Errata to ASME PTC 19.3 TW-2010 Thermowells

The errata corrections listed below apply to ASME PTC 19.3 TW-2010. These corrections will be incorporated into the next edition of ASME PTC 19.3 TW.

(b) Socket Weld Thermowell

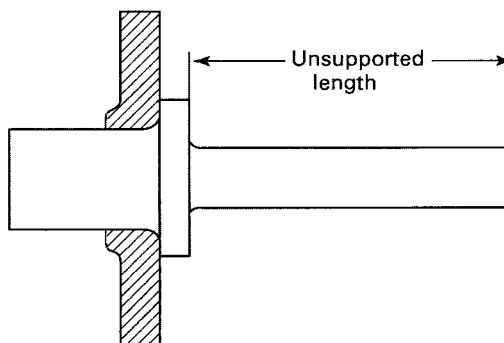
| <i>Page</i> | <i>Location</i> | <i>Change</i> |
|-------------|-----------------|---|
| 17 | Fig. 6-6-1 | (1) Illustrations (b) and (c) corrected to include welds (see figure on overleaf) (2) Shading added to illustration (c) (see overleaf) |
